APPEAL # 3

CASE 2022-3064-PR

Take 5 car wash approval of
Plan Review

ZONING STAFF REPORT
2022-3064-PR

SHEET TITLE LAYOUT & CONTROL PLAN
 PROJECT NUMBER 21-055
 DATE 09.09.22
 SCALE AS NOTED
 DRAWN AS NOTED
 CHECKED AS NOTED
 SHEET NO C-100

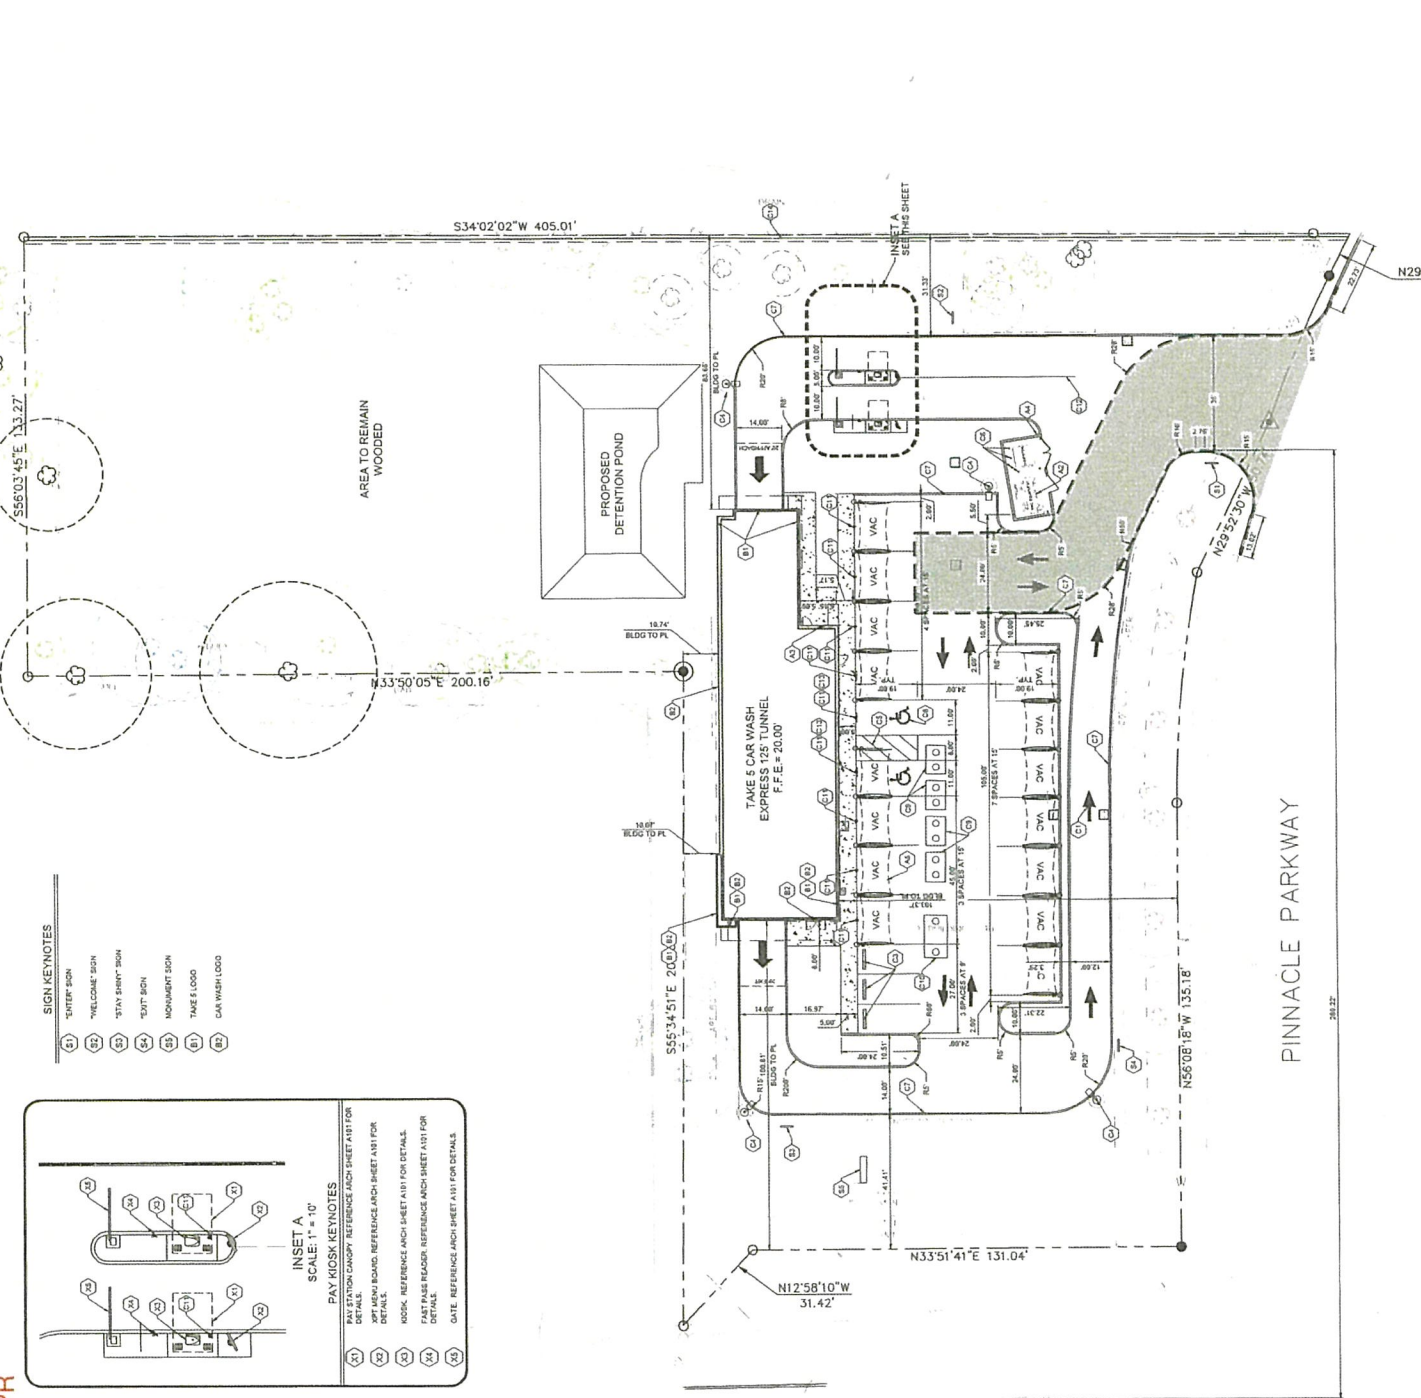
1. Per Sec. 130-1814(1)(e)(1)(ii), a nonresidential property abutting a residential district shall have a minimum side yard and rear yard requirement of 30 feet.
 - **The current proposed plans show a proposed 8 ft. sound barrier wall located along the eastern line of the required 30-foot eastern buffer abutting the adjoining Flowers Estates subdivision. This location will require the removal of a 28" pine tree, a 14" pine tree, and an 8" red maple within the no cut buffer and will therefore require a waiver to the Side and Rear Planting Area Regulations.**
 - **Should the Zoning Commission be in favor of the proposed 8 ft. sound barrier wall, it should be subject to revisions of the civil and landscape plans to provide cross section details, setbacks from the property line, and construction details.**

SHEET TITLE
LANDSCAPE PLAN

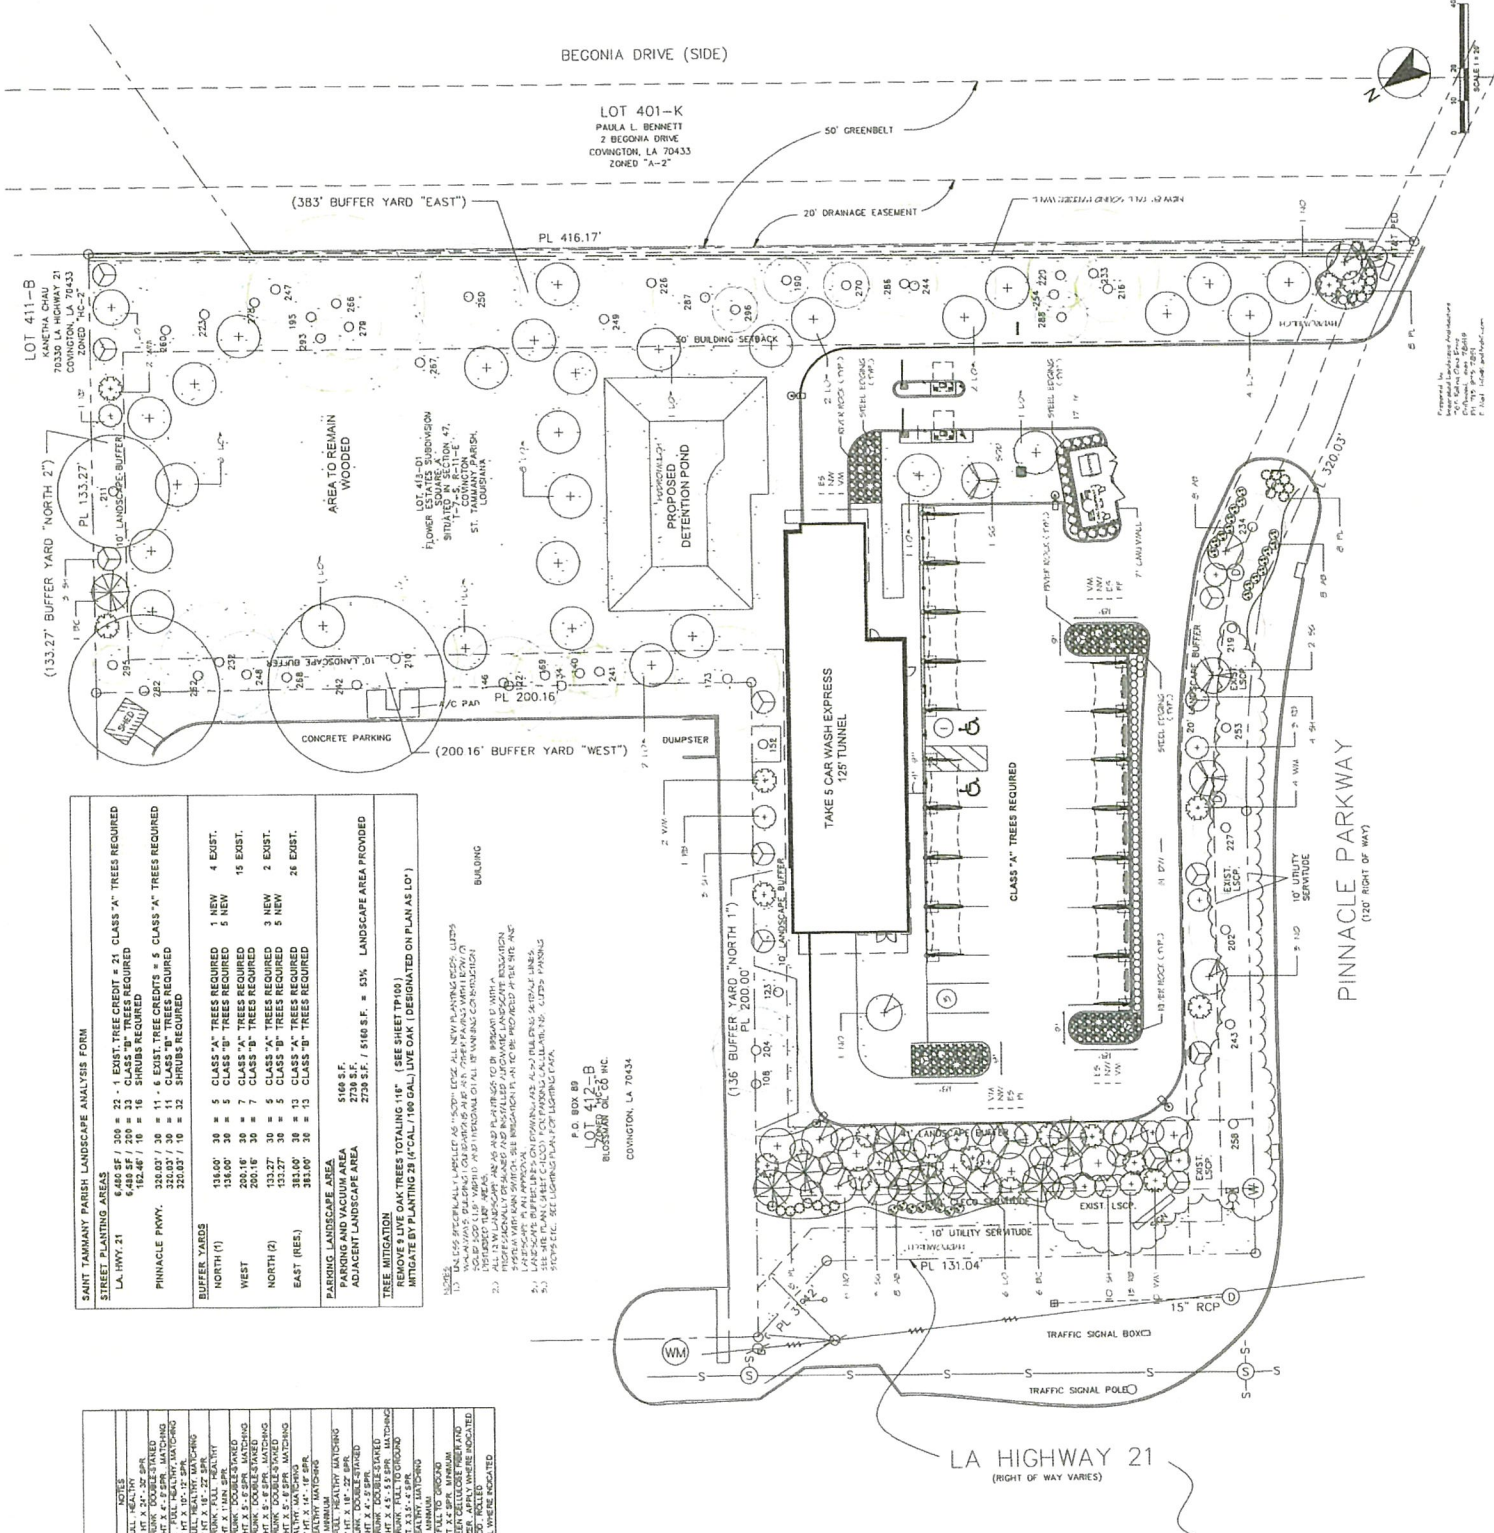
1. The applicant is proposing to remove 9 of 20 existing live oaks where it has been determined by the project team's landscape architect that too much of their critical root zones are in areas of new paving construction.

- a. Removal of live oaks require mitigation, and the applicant is required to flag all live oaks in the field and schedule an inspection with the Department of Planning and Development. The Planning Department's landscape architect will grade the live oaks and provide the number of mitigation inches required based on the average quality of the trees. The landscape plan is currently proposing the mitigation planting of 29 live oak trees.

- b. Staff has concerns regarding the number of proposed live oaks to be planted on the site and recommends reducing the proposed total of live oaks to ensure future growth and survival. Staff recommends that the applicant revise the proposed planting plan to fit a reasonable number of live oaks on the site and pay the remaining credits into the tree bank at a maximum 50% of the required mitigation inches.

2. While the landscape plan meets code and shows the required number of Class A and Class B plantings, staff recommends reduction of live oaks proposed to be planted to a maximum of three in order to ensure survival and appropriate growth.
